Proposal for an Amendment to UN Global Technical Regulation No. 13 (Hydrogen and Fuel Cells Vehicles)

Submitted by the Task Force amending UN Regulation No. 134 (Hydrogen and Fuel Cells Vehicles) *

Figure 2

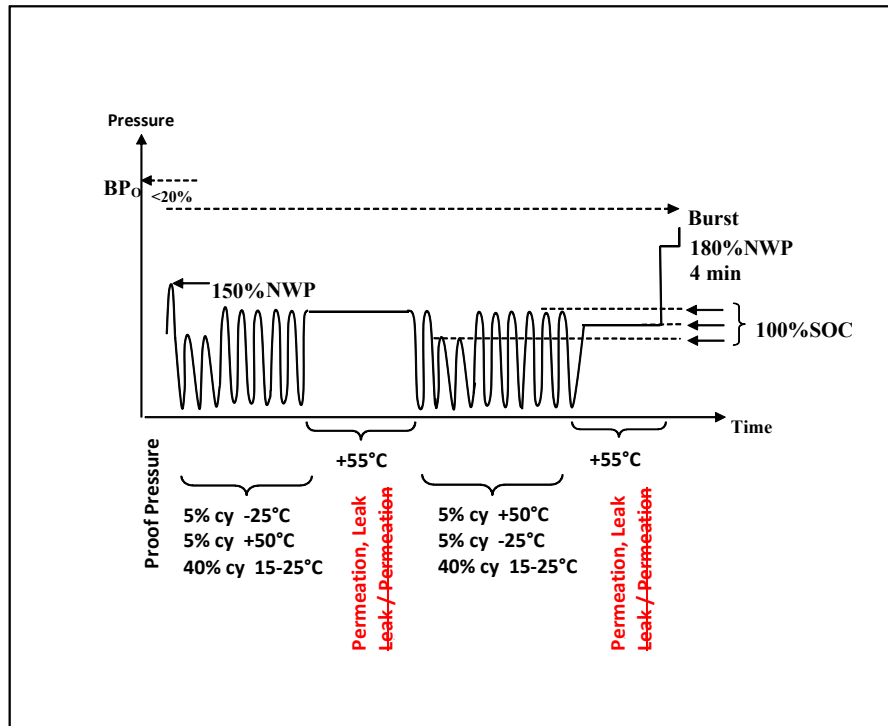
"5.1.3. Verification test for expected on-road performance (Pneumatic sequential tests)

A CHSS shall undergo the following sequence of tests, which are illustrated in Figure 2. Specifics of applicable test procedures for the CHSS are provided in paragraph 6.2.4.

The CHSS shall not leak and the primary closure devices shall maintain functionality during the test.
